This document addresses transceiver-related known errata for the Stratix<sup>®</sup> GX FPGA family production devices.

**Figure 2. Gigabit Transceiver Block Clock Configuration that can Potentially Cause Byte Misalignment Problem, Example 1**

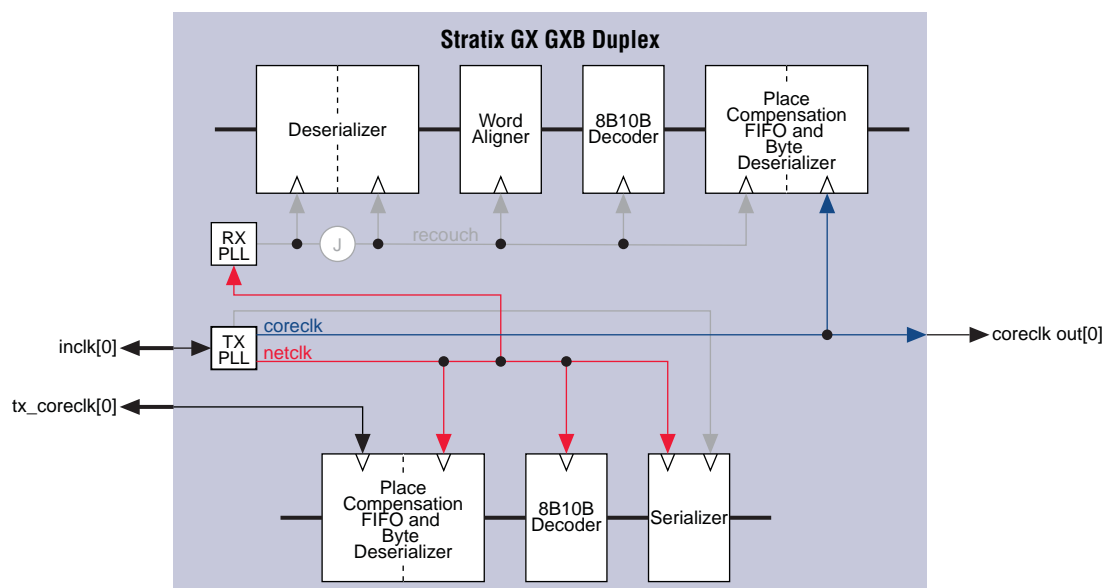
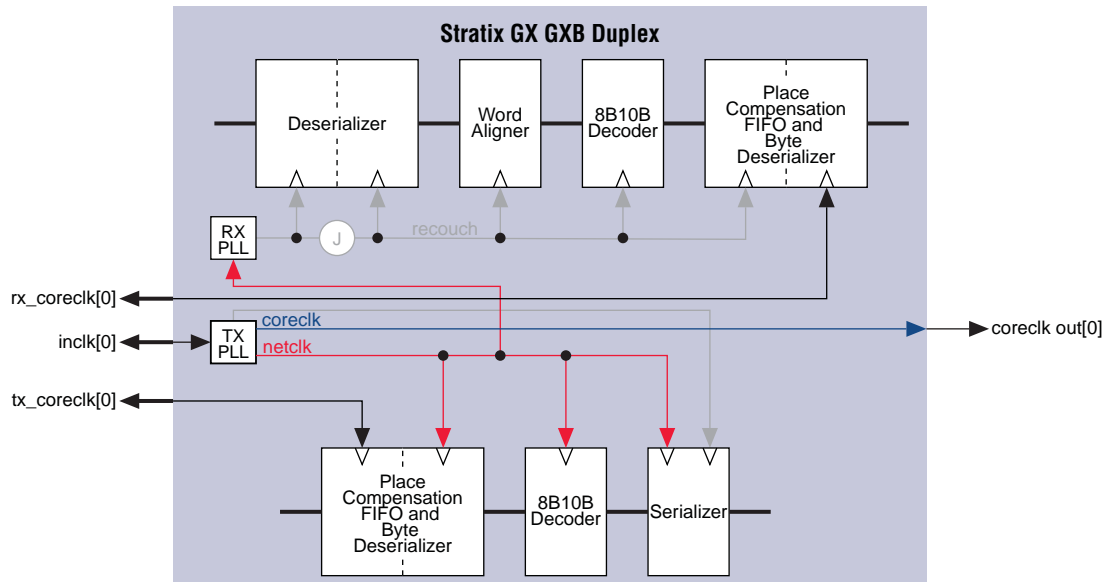
The clocking configurations in Figure 2 and Figure 3 can only work if both the read and write clocks to the phase compensation FIFOs are of the same frequency. Take proper precautions to ensure that there is no frequency variation anytime after the link has been initialized. This means that you must perform a receiver digital reset via the `rxdigitalreset` signal to ensure that the pointers within the receiver phase compensation FIFO are properly spaced.

If you are using these clocking configurations, you must be aware that, in these configurations, the output byte alignment can potentially vary between six different permutations. That is, after the de-assertion of the `rxdigitalreset` signal, the byte ordering can deviate from the previously explained two permutations.

The recommended workaround is to run the gigabit transceiver block in the default clocking scheme, as described above, and implement a phase compensation FIFO in the FPGA logic array. This configuration of the gigabit transceiver block will prevent byte misalignment. This would utilize additional resources and increase latency in the datapath. A phase compensation FIFO can be implemented in the FPGA logic array

**Figure 4. Byte Misalignment at the Receiver Interface**

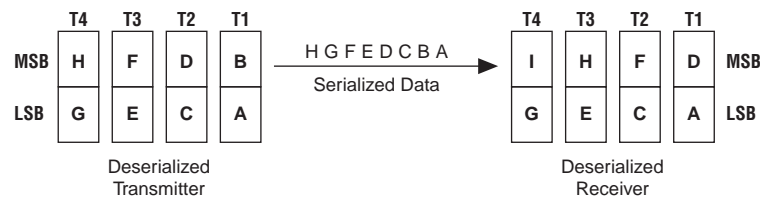
If the transceiver is clocked by any of the methods other than the default method described above, there is a possibility of byte misalignment. Figure 4 provides an example of byte misalignment.

**Figure 5. Block Level Example of Byte Re-Alignment Logic**

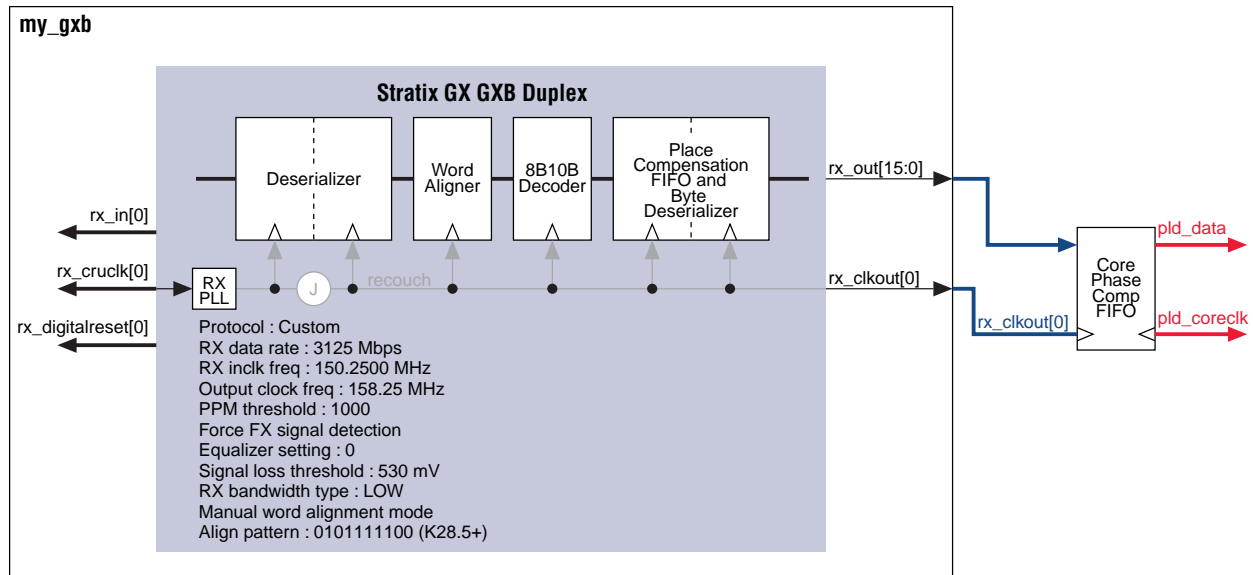
using a Dual Port RAM, however you decide on the FIFO parameters to meet system specifications. Another thing to be aware of is the additional clock resources needed for this implementation. Each channel will require the use of a global, regional, or fast regional routing resource for the recovered clock (`rx_clkout`) to be routed out of the gigabit transceiver block. Figure 5 shows an example of this workaround.

**Figure 8. Determine if the Stratix GX Design is Affected**

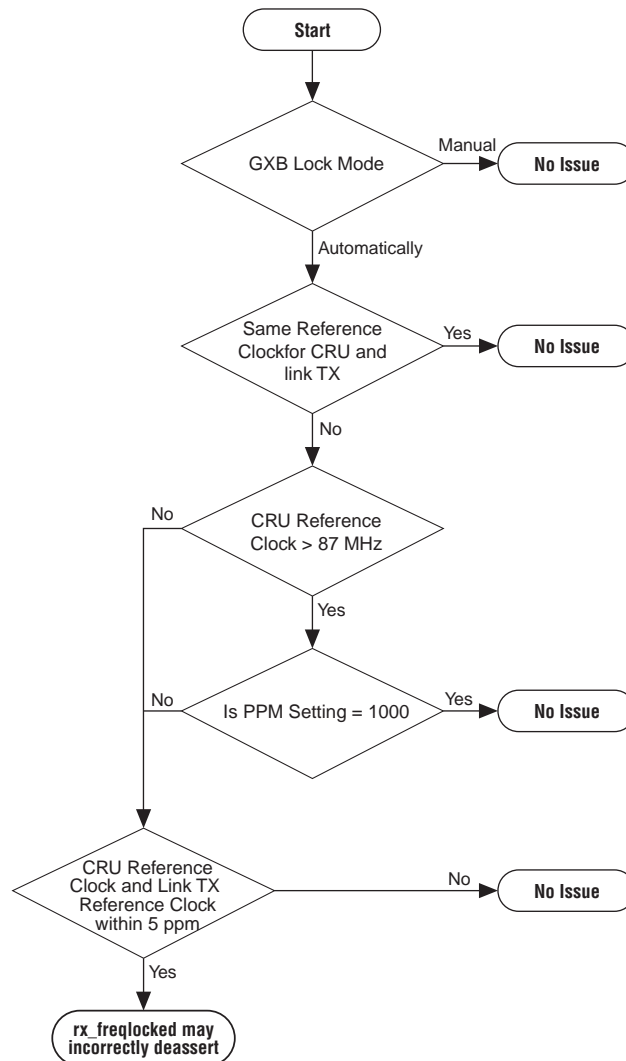
Under certain conditions, the rx\_freqlocked signal has an issue in the automatic lock mode. The rx\_freqlocked signal might incorrectly deassert even if the CRU PLL and the CRU reference clock are within the selected PPM frequency threshold detector setting.

The rx\_freqlocked signal can demonstrate incorrect behavior if:

- The CRU reference clock and the link TX clock are not from the same source AND
- The PPM difference between the CRU reference clock and the recovered clock is less than 5 PPM AND
- Input reference clock is between 25 MHz and 87 MHz

Figure 8 shows a flow chart that helps you determine if your Stratix GX design is affected.

Altera recommends using the manual lock mode for the transceivers. Design the PPM frequency threshold detector in the PLD fabric. A design example for implementing the PPM frequency threshold detector can be found at:
